Appendices

Appendix C: Facility Reports for City Buildings and Parks

Appendix D: Facility Reports for Downtown Parking Lots

Appendix E: Public Rights-of-Way Reports for City Facilities and Schools

Civic Center Campus - Path of Travel and Parking
 One North San Antonio Road
 Los Altos, CA

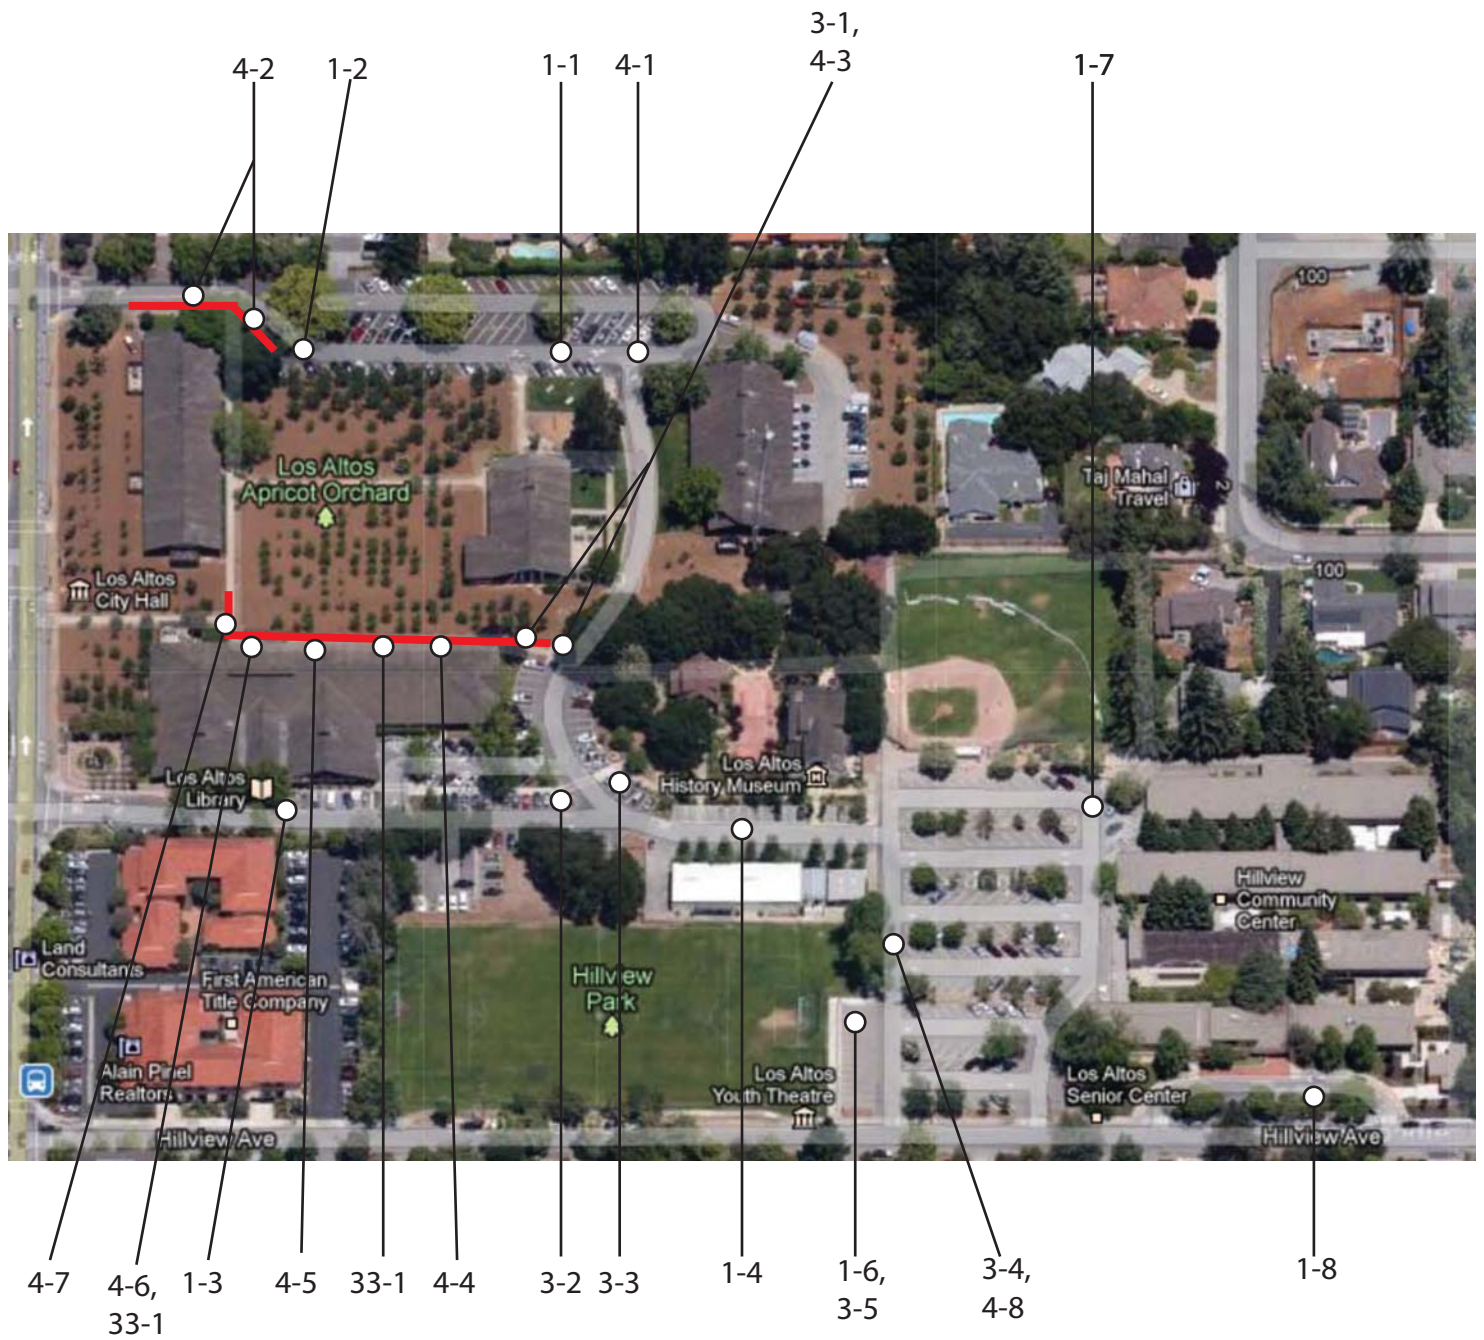
Exterior		
1 - 1	Parking Area	Priority: 1
Install sign		\$500
Notes: "Minimum Fine \$250" is not provided.		
State: 1129B.4		
Federal: -		
1 - 2	Parking Area	Priority: 1
Install sign		\$500
Notes: "Minimum Fine \$250" sign is not provided.		
State: 1129B.4		
Federal: -		
Regrade surface		\$2,000
Notes: Slopes in the both parking space and access aisle up to 2.5% (2% max.)		
State: 1129B.3.4		
Federal: -		
Provide or modify accessible spaces		\$1,000
Notes: Length of parking stall is 15'-4" (18'-0" min.)		
State: 1129B.3		
Federal: -		
1 - 3	Parking Area	Priority: 1
Provide or modify accessible access aisles		\$1,000
Notes: Van access aisle is 7'-9" (8'-0" min.). The words "NO PARKING" are not painted in both access aisles.		
State: 1129B.3.1		
Federal: -		
Regrade surface		\$1,000
Notes: Slopes in Van access aisle ranges from 2.1-6.6% due to built up curb ramp. Second access aisle slope ranges from 2.1-10.9% due to built up curb ramp. (2% max.)

Exterior		
1 - 4	Parking Area	Priority: 1
Install van parking sign		\$500
Notes: Van parking sign is not provided.		
State: -		
Federal: 208.2.4		
Install sign		\$500
Notes: "Minimum Fine \$250" sign is not provided.		
State: 1129B.4		
Federal: -		
Regrade surface		\$1,000
Notes: Slopes in the access aisle range from 2.7-3.5% (2% max.)		
State: 1129B.3.4		
Federal: -		
Provide or modify accessible access aisles		\$1,000
Notes: The words "NO PARKING" are not provided in the access aisle.		
State: 1129B.3.1		
Federal: -		
Provide or modify accessible spaces		\$1,000
Notes: Length of both stalls are 16'-6" due to valley gutter (18'-0" min.)		
State: 1129B.3		
Federal: -

Exterior		
1 - 5	Parking Area	Priority: 1
Install van parking sign		\$500
Notes: Van parking sign is not provided.		
State: -		
Federal: 208.2.4		
Install sign		\$500
Notes: "Minimum Fine \$250" sign is not provided.		
State: 1129B.4		
Federal: -		
Regrade surface		\$2,000
Notes: Slopes in two access aisles range from are 5% due to built up curb ramp. (2% max.)		
State: 1129B.3.4		
Federal: -		
Provide or modify accessible access aisles		\$1,000
Notes: The words "NO PARKING" are not provided in the access aisle.		
State: 1129B.3.1		
Federal: -		
Remove overhanging or protruding objects		\$1,000
Notes: Parking ISA sign is mounted 42" above grade and is in the path of travel.		
State: 1129B.3.4		
Federal: -		
1 - 6	Parking Area	Priority: 1
Install van parking sign		\$500
Notes: Van parking sign is not provided.		
State: -		
Federal: 208.2.4		
Install sign		\$500
Notes: "Minimum Fine \$250" sign is not provided.		
State: 1129B.4

Federal: -		
Provide or modify accessible access aisles		\$1,000
Notes: Access aisle is not provided.		
State: 1129B.3.1		
Federal: -

Exterior		
1 - 7	Parking Area	Priority: 1
Install van parking sign		\$500
Notes: Van parking sign is not provided.		
State: -		
Federal: 208.2.4		
Install sign		\$500
Notes: "Minimum Fine \$250" sign is not provided.		
State: 1129B.4		
Federal: -		
Regrade surface		\$2,000
Notes: Slopes in the access aisle up to 5.5%. Slopes in parking space range between 2.8-3.5% (2% max.)		
State: 1129B.3.4		
Federal: -		
Provide or modify accessible access aisles		\$1,000
Notes: Access aisle is located on the drivers side. The words "NO PARKING" are not provided in the access aisle.		
State: 1129B.3.1		
Federal: -

Exterior		
1 - 8	Parking Area	Priority: 1
Install sign for unauthorized parking		\$500
Notes: Warning sign is not provided at parking lot entrance.		
State: 1129B.4		
Federal: -		
Install sign		\$500
Notes: "Minimum Fine \$250" is not provided.		
State: 1129B.4		
Federal: -		
Provide or modify accessible spaces		\$2,000
Notes: There is no formal access aisle. One large accessible space is provided that is 12 ft. 17 ft. will be required for Van Accessible space. Length of space is 16 ft. (18ft min.)		
State: 1129B.1, 1129B.3, 1129B.4		
Federal: -		
Install van parking sign		\$500
Notes: Van accessible sign is not provided.		
State: -		
Federal: 208.2.4		
Regrade surface		\$1,000
Notes: Designated accessible parking space has slopes up to 3.2% (2% max.)		
State: 1129B.3.4		
Federal: -		
3 - 1	Curb Ramp	Priority: 1
Provide detectable warning strip		\$1,000
Notes: Detectable warning is not provided on the curb ramp.

State: 1127B.5.7, IR11B-4		
Federal: -		
Provide surface texturing		\$1,000
Notes: Grooved border is not provided.		
State: 1127B.5.6		
Federal: -		
Repair surface		\$2,000
Notes: There is a 1/2" lip at the the base of the curb ramp.		
State: 1127B.5.3		
Federal: 405.4

Exterior		
3 - 2	Curb Ramp	Priority: 1
Provide detectable warning strip		\$1,000
Notes: Detectable warning is not provided on the curb ramp.		
State: 1127B.5.7, IR11B-4		
Federal: -		
3 - 3	Curb Ramp	Priority: 1
Provide detectable warning strip		\$1,000
Notes: Detectable warning is not provided on the curb ramp.		
State: 1127B.5.7, IR11B-4		
Federal: -		
3 - 4	Curb Ramp	Priority: 1
Provide detectable warning strip		\$1,000
Notes: Detectable warning is not provided on the curb ramp.		
State: 1127B.5.7, IR11B-4		
Federal: -		
Provide surface texturing		\$1,000
Notes: Grooved border is not provided.		
State: 1127B.5.6		
Federal: -		
Install, replace or modify curb ramp		\$5,000
Notes: Slopes of flared sides up to 25% (10% max.)		
State: 1127B.5.3, 1127B.5.4		
Federal: 406.3		
3 - 5	Curb Ramp	Priority: 1
Install, replace or modify curb ramp		\$5,000
Notes: Slope of curb ramp ranges from 9-11% (8.33% max.)		
State: 1127B.5.3

Federal: 405.2		
4 - 1	Walk	Priority: 1
Provide detectable warning strip		\$750
Notes: Detectable warning should be provided where walk meets vehicular area. 30'-0"		
State: 1133B.8.5		
Federal: -

Exterior		
4 - 2	Walk	Priority: 1
Provide detectable warning strip		\$575
Notes:	Detectable warning should be provided where walk meets vehicular area. 17'-0" with 6'-0" return.	
State:	1133B.8.5	
Federal:	-	
Regrade surface		\$2,500
Notes:	Cross slopes up to 6% on walkway (2% max.) 25'-0"	
State:	1133B.7.1.3	
Federal:	403.3	
4 - 3	Walk	Priority: 1
Regrade surface		\$800
Notes:	Running slope of walkway is 6.3% (5% max.) 8'-0" (near 3-1)	
State:	1133B.7.3	
Federal:	403.3	
4 - 4	Walk	Priority: 1
Regrade surface		\$2,500
Notes:	Cross slope of walkway is 6% (2% max.) 25'-0" (near pergola behind library)	
State:	1133B.7.1.3	
Federal:	403.3	
4 - 5	Walk	Priority: 1
Regrade surface		\$3,000
Notes:	Cross slope of brick walkway is 5% (2% max.) 30'-0" (under pergola)	
State:	1133B.7.1.3	
Federal:	403.3	
4 - 6	Walk	Priority: 1
Repair surface		\$1,000
Notes:	There is a 1" gap in the walk with a 3/4" change in level (1/4" max.) near the bench.

State:	1124B.2	
Federal:	303.2, 303.3	
4 - 7	Walk	Priority: 1
Repair surface		\$1,000
Notes:	There is a 1/2" change in level (1/4" max.)	
State:	1124B.2	
Federal:	303.2, 303.3

Exterior		
4 - 8	Walk	Priority: 1
Regrade surface		\$200
Notes: Cross slope of brick walkway is 8.2% (2% max.) 2'-0" near 3-5		
State: 1133B.7.1.3		
Federal: 403.3		
33 - 1	Outdoor Constructed Features	Priority: 3
Increase or provide maneuvering or clear floor area		\$2,000
Notes: Companion seating is not provided for the bench.		
State: -		
Federal: AGODA 1011.2.1		
Provide accessible fixed bench		\$2,000
Notes: Bench seat height is 16" (17-19" req.)		
State: -		
Federal: 903.5		
33 - 2	Outdoor Constructed Features	Priority: 3
Increase or provide maneuvering or clear floor area		\$2,000
Notes: Companion seating is not provided for the bench.		
State: -		
Federal: AGODA 1011.2.1		
Provide accessible fixed bench		\$2,000
Notes: Bench seat height is 16" (17-19" req.)		
State: -		
Federal: 903.5

Blach Gym
1120 Covington Road
Los Altos, CA

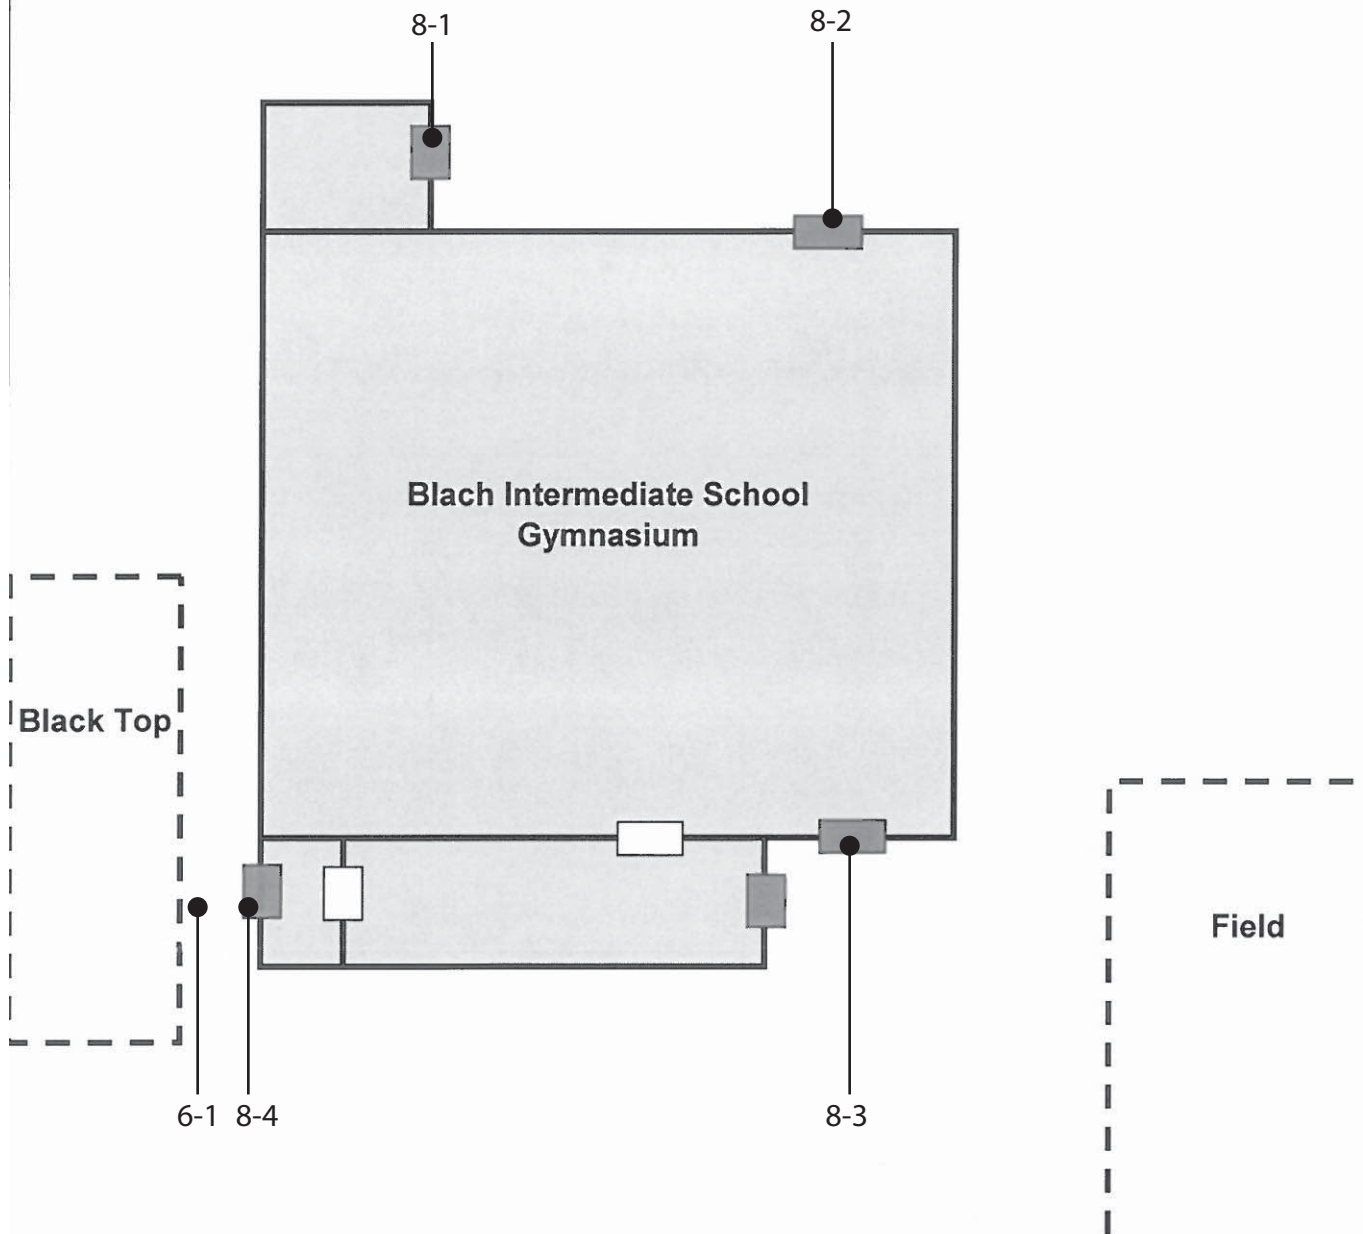
Floor 1		
8 - 1	Door/Gate	Priority: 1
Install or modify permanent room signs		\$250
Notes: Braille EXIT sign is not provided.		
State: -		
Federal: 1011.3		
Adjust door closer		\$500
Notes: Operating effort is 15-20lbs for both doors. (5lbs max.)		
State: 1133B.2.5		
Federal: 404.2.9		
Provide sign(s) indicating accessible entries and facilities		\$1,000
Notes: The designated accessible entrance is not marked with the International Symbol of Accessibility.		
State: 1117B.5.8.1.2		
Federal: 216.6, 703.7.2.1		
8 - 2	Door/Gate	Priority: 1
Install or modify permanent room signs		\$250
Notes: Braille EXIT sign is not provided.		
State: -		
Federal: 1011.3		
Adjust door closer		\$500
Notes: Operating effort is 10lbs for both doors. (5lbs max.)		
State: 1133B.2.5		
Federal: 404.2.9		
Provide sign(s) indicating accessible entries and facilities		\$1,000
Notes:		
State: -		
Federal: -		
8 - 3	Door/Gate	Priority: 1
Install or modify permanent room signs		\$250

Floor 1		
8 - 4	Door/Gate	Priority: 1
Install or modify permanent room signs		\$250
Notes: Braille EXIT sign is not provided.		
State: -		
Federal: 1011.3		
Adjust door closer		\$500
Notes: Operating effort is 11-12lbs for both doors. (5lbs max.)		
State: 1133B.2.5		
Federal: 404.2.9

Bus Barn Theater
161 South San Antonio Road
Los Altos, CA

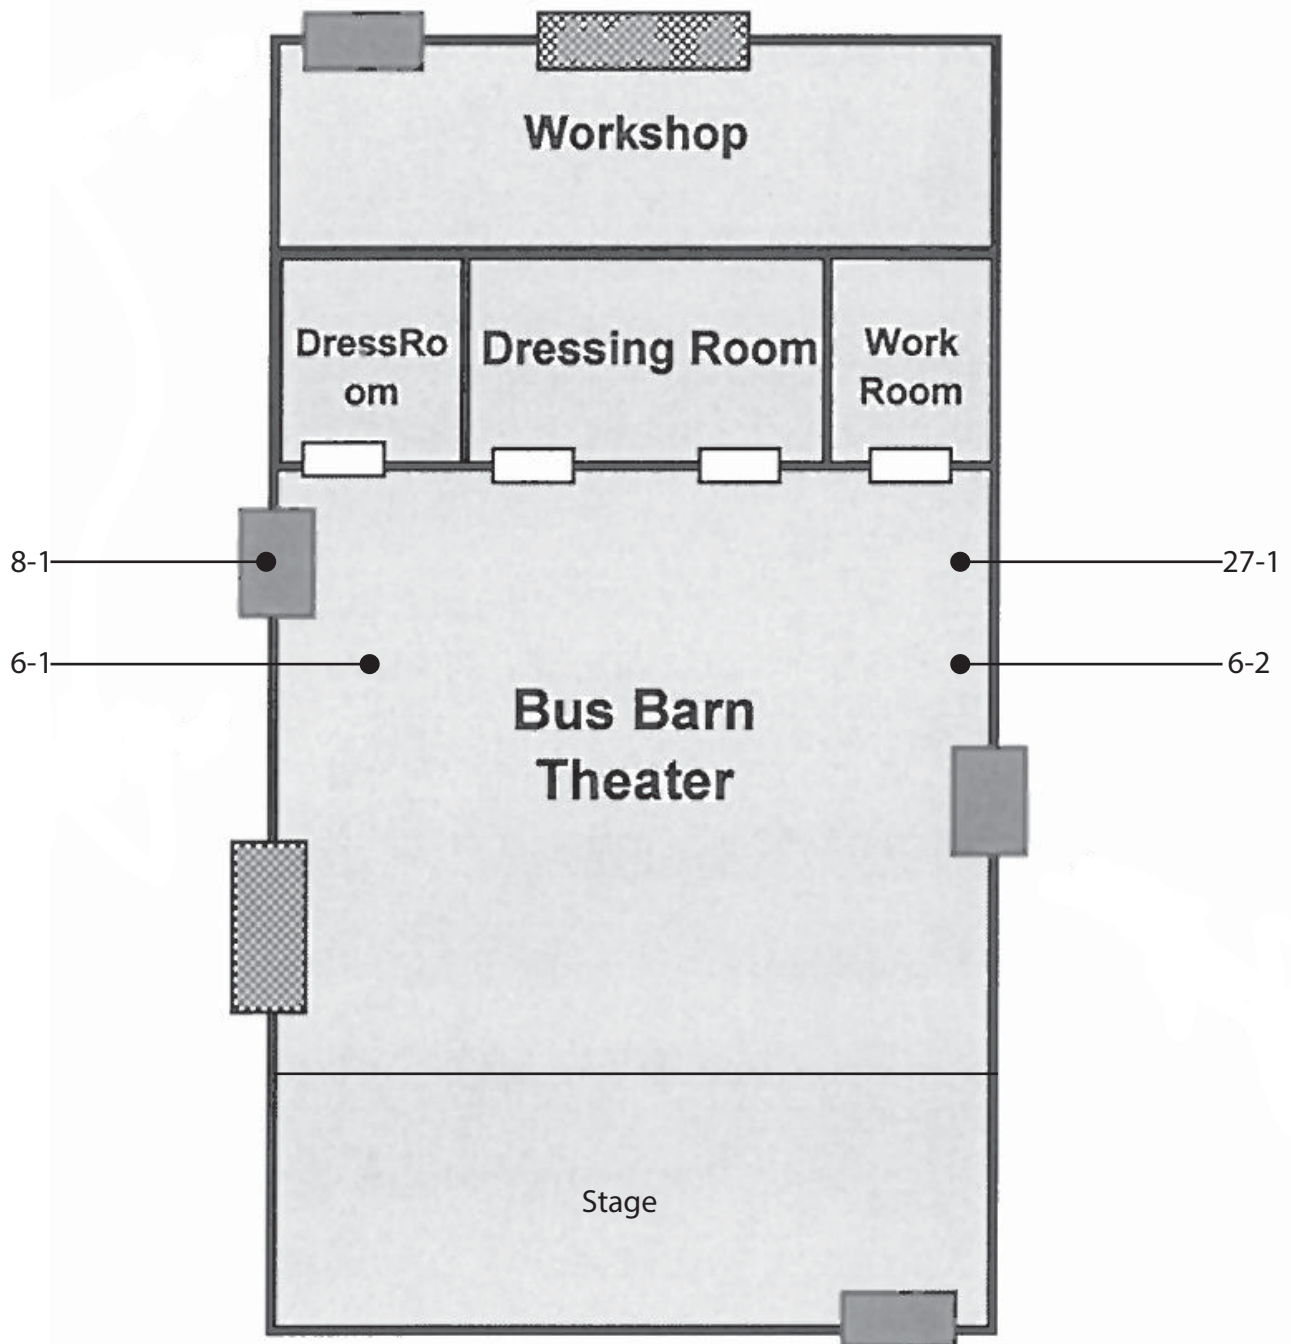
Floor 1		
6 - 1	Stairway	Priority: 2
Install or modify handrails		\$5,000
Notes: Handrails do not have extensions on top and bottom.		
State: 1133B.4.2.2		
Federal: 505.10.2		
Replace stairs		\$6,000
Notes: Open risers are not permitted. Riser height is 8-1/2" (4-7" req.) There are 6 risers.		
State: 1133B.4.5, 1133B.4.5.3		
Federal: 504.2		
Install tread striping		\$50
Notes: Indicator stripes are worn and need to be replaced on the top and bottom risers.		
State: 1133B.4.4		
Federal: -		
6 - 2	Stairway	Priority: 2
Install or modify handrails		\$5,000
Notes: Handrails do not have extensions on top and bottom.		
State: 1133B.4.2.2		
Federal: 505.10.2		
Replace stairs		\$6,000
Notes: Open risers are not permitted. Riser height is 8-1/2" (4-7" req.) There are 6 risers.		
State: 1133B.4.5, 1133B.4.5.3		
Federal: 504.2		
Install tread striping		\$50
Notes: Indicator stripes are worn and need to be replaced on the top and bottom risers.

Floor 1		
8 - 1	Door/Gate	Priority: 1
Provide or modify door kickplate		\$500
Notes: There is a door stop on the kick plate.		
State: 1133B.2.6		
Federal: 404.2.10		
Provide additional strike edge clearance		\$5,000
Notes: Strike edge clearance on the push side of the door is 2" (12" min.)		
State: 1133B.2.4.2		
Federal: 404.2.4.1		
Increase or provide maneuvering or clear floor area		\$2,000
Notes: Slope on the swing side of the door is 4.5% (2% max.)		
State: 1133B.2.4.2		
Federal: 4.16.3		
27 - 1	Assembly Area	Priority: 2
Provide accessible seating		\$2,500
Notes: Accessible theater seating is not provided. Companion seating is not provided. There are 100 seats.		
State: 1104B.3.5		
Federal: 221.3, 802.3		
Provide an assistive listening system		\$5,000
Notes: Assistive listening devices are not provided.		
State: -		
Federal: 1104B.2.3, 1104B.2.6
